Weep holes should always be located directly on the flashing.

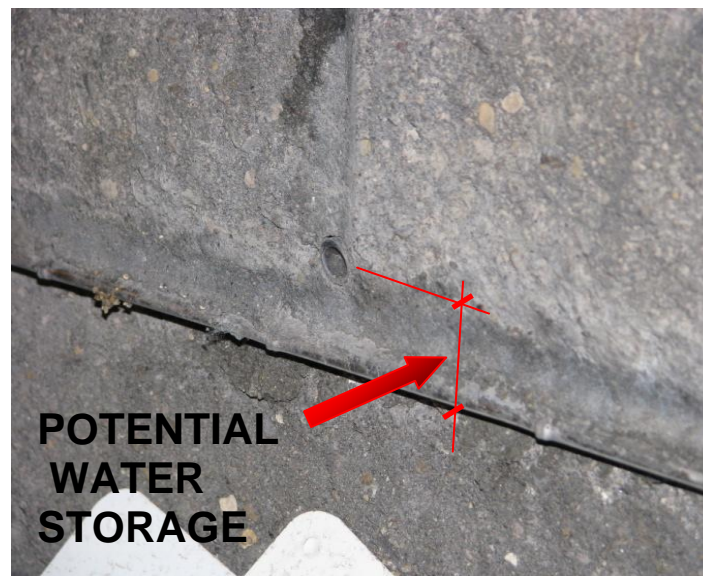
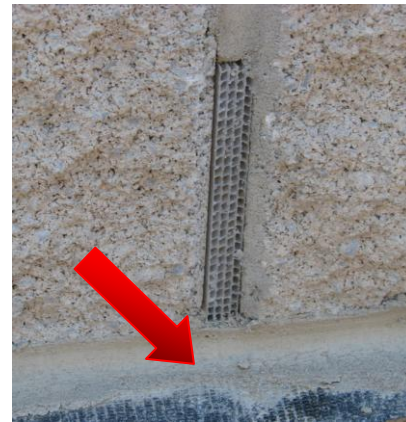
Weep holes located on top of mortar above flashing does not work and will create a wall issue due to water storage!

We need to be **reviewing and verifying** the weep locations with the Sub-contractor early in the installation process and throughout the installation.
